2. Information of Main Modifications after Issue of Service Manual

Note: Following modifications are already applied for the Europe version.

Fig. 11 Tuner P.C.B. Ass’y

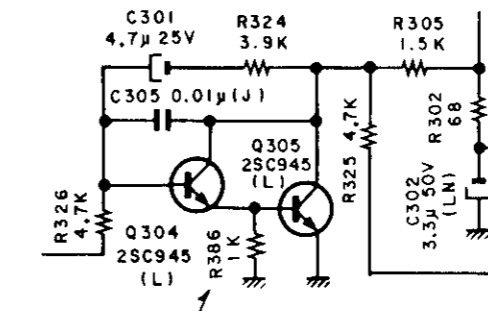
R386 (1 KΩ) has been added between the base and emitter (GND) of Q305 on the Tuner P.C.B. Ass’y in order to improve the FM S/N ratio approx. 5 dB.

Added: R386 0B09667A Carbon Resistor
1KΩ 1/6W J

Fig. 12 CPU Control P.C.B. Ass’y

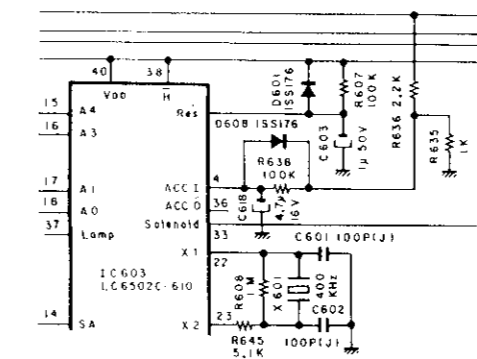
R635 on the CPU P.C.B. Ass’y has been changed from 2.2 K to 1 K. When a car without ACC position is used, ACC line voltage drops when the starter of the car is activated, resulting in erroneous CPU operation. To prevent this R635 has been changed.

Added: R635 0B01857A Carbon Resistor
1KΩ 1/4W J

Removed: R635 0B05622A Carbon Resistor
2.2KΩ 1/4W J

Fig. 13

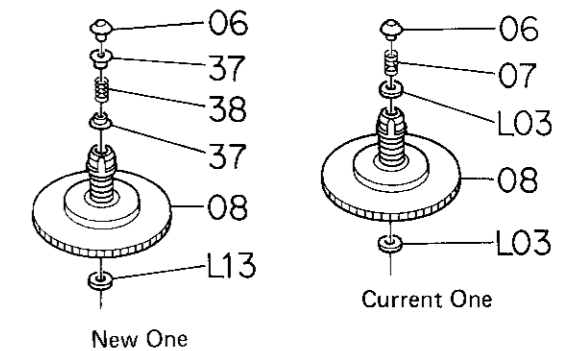
To obtain stronger torque and better wow/flutter characteristics, back tension spring and associated parts have been changed.

- 06: 0C08445A Reel Hub Cap
- 37: 0C08589A Tension Spring Sleeve
- 38: 0C08467D Back Tension Spring
- L13: 0E03132A Washer 2.1x6x0.25t

- 06: 0C08445A Reel Hub Cap
- 07: 0C08467C Back Tension Spring
- 08: CA08424A Reel Table Ass’y
- L03: 0E03061A Washer 2.1 mm
